Randwick Local Planning Panel (Public) Meeting

Thursday 13 April 2023

Development Application Report No. D19/23

Subject: 3 & 4 Llanfoyst Street, Randwick (DA/526/2022)

Figure 7: Figures 3 & 4 Referenced in the Applicant's 4.6 Variation request (Source: GSA Planning).

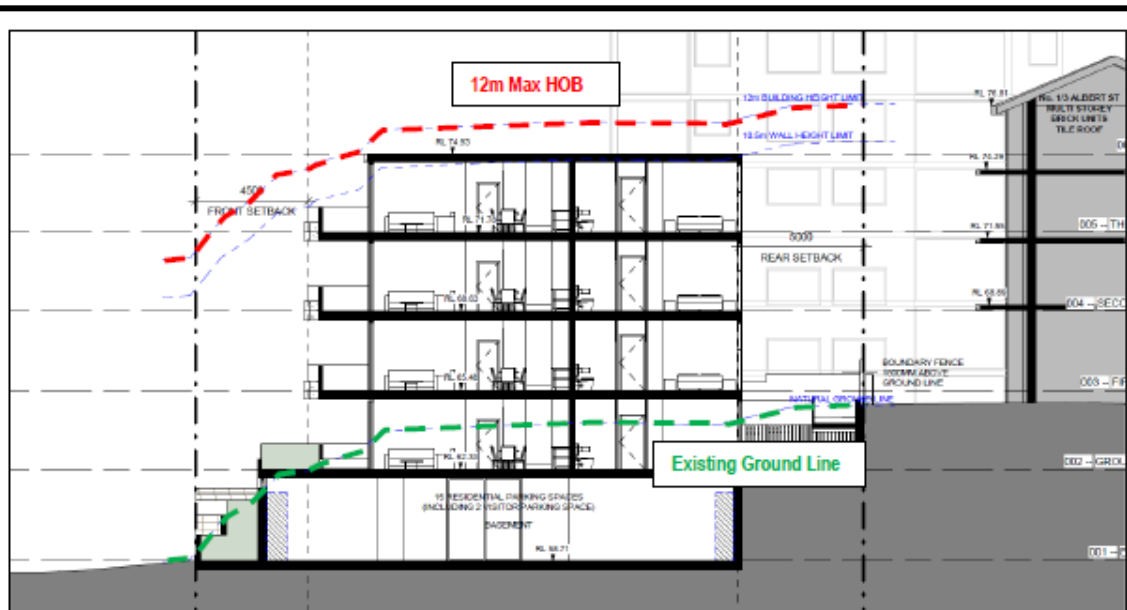
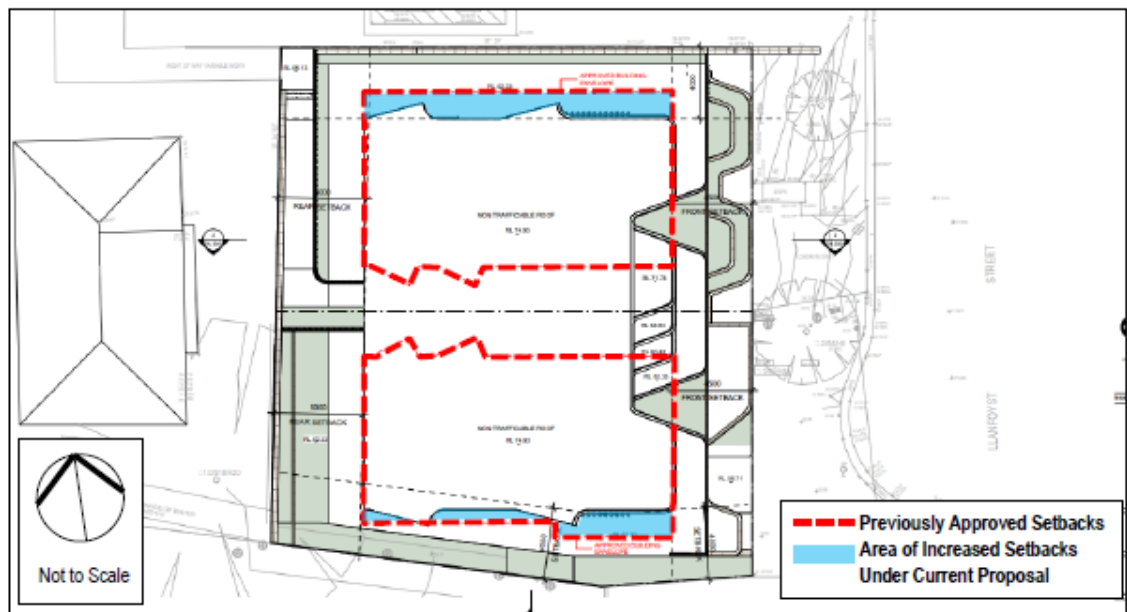
Assessing officer's comment: As discussed below, the reasons stated in the applicant's written request are not concurred with. It is considered that the proposal does not uphold objectives a) and d) of the floor space ratio development standard. As such, the applicant has not adequately demonstrated that compliance with the development standard is unreasonable or unnecessary in the circumstances of the case

The Applicant has not adequately addressed how compliance with the development standard is unreasonable and unnecessary in this case. In conclusion, the Applicant's written request has not adequately demonstrated that there are sufficient environmental planning grounds to justify the contravention. Furthermore, Council is of the opinion that the entire building envelope is being altered given the changes proposed, and therefore it cannot be argued that the proposed development is the same as originally approved.

Figure 6 – Council's calculation of site coverage includes the building footprint at ground level

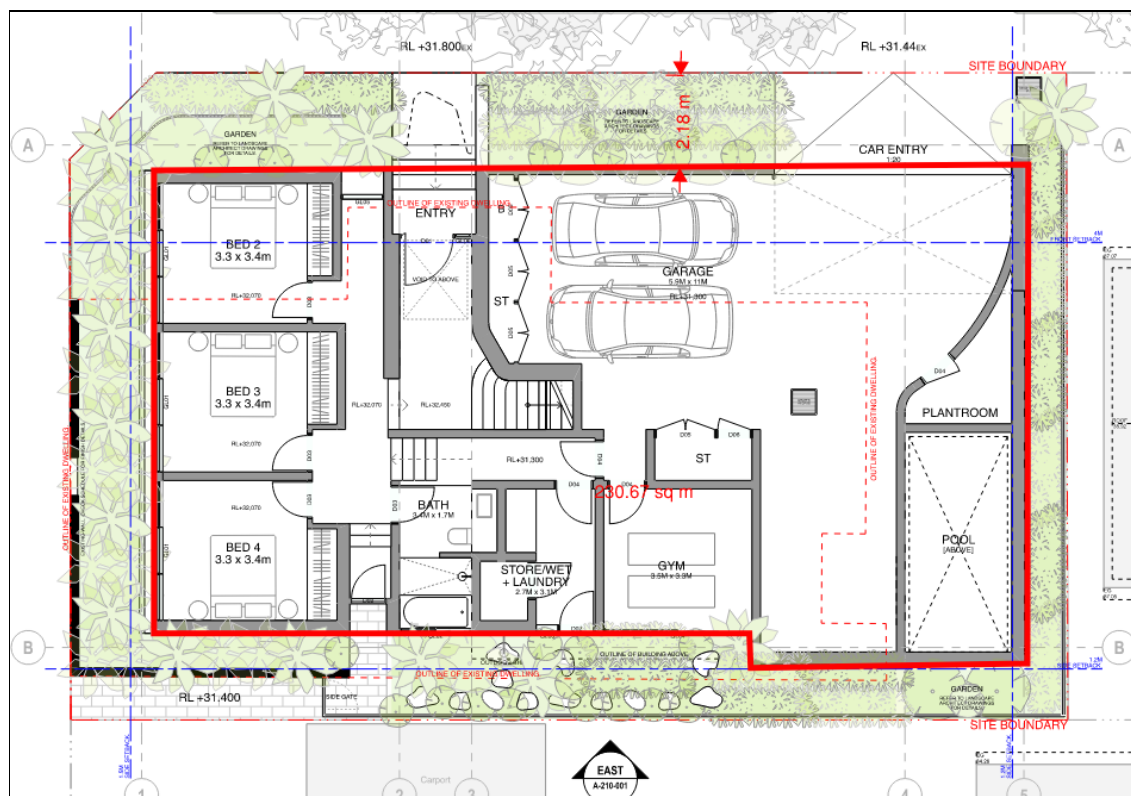
A maximum site coverage of 55% applies to the site under Part C1 Section 2.3 of RDCP 2013. The architectural plans submitted with the application indicate a site coverage of 194.6m², which equates to 54.9%. There is no site coverage plan submitted with the original application to show how the site coverage was calculated. It appears the applicant excluded the swimming pool from the calculation of site coverage. However, the swimming pool is within the building structure and therefore it should be included in the site coverage calculation. Based on Council's mapping tool, the building covers 230m² of the site, which equates to 64% and exceeds the maximum 55% site coverage control (Refer to **Figure 6**).

Figure 7. Proposed privacy screen and sightlines – submitted by applicant as additional information. The drawing is not to scale.

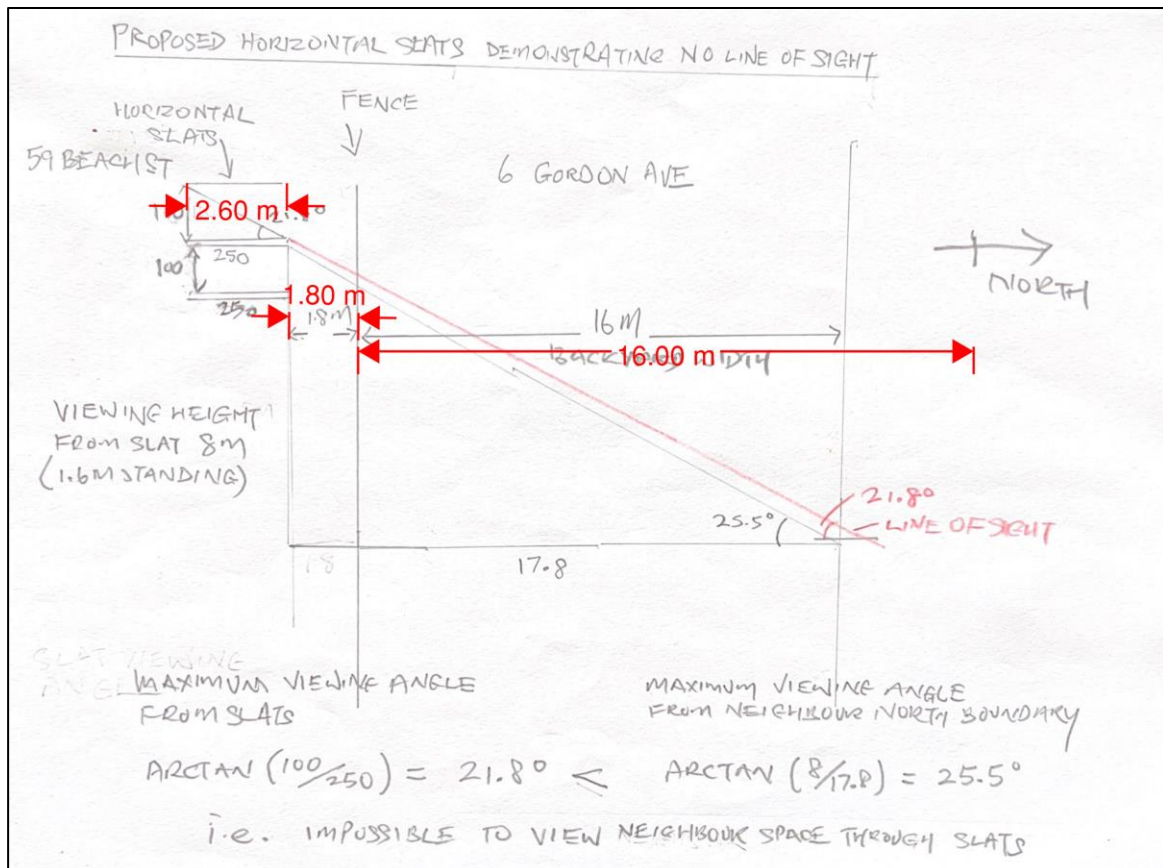
As per the applicant's drawing in Figure 7, the privacy screens are proposed to be composed of horizontal slats, with 100mm gaps between each slat. The depth of the slat is 250mm. The drawing intends to show that there is no line of sight into the private open space. However, the drawing is not to scale and thus does not accurately demonstrate the line of sight.

The assessing officer conducted a site inspection at the subject site, which is currently under construction, on 29 September 2022. The applicant presented the construction of a mockup of the privacy screen design, as seen in Figure 6 – the mockup does not show all the proposed horizontal slats, which are intended to be spaced out by 100mm down to the sill. Nonetheless, the proposed horizontal slat design does allow views into the adjoining property through the large gaps. The slats are not appropriately spaced to mitigate privacy impact.
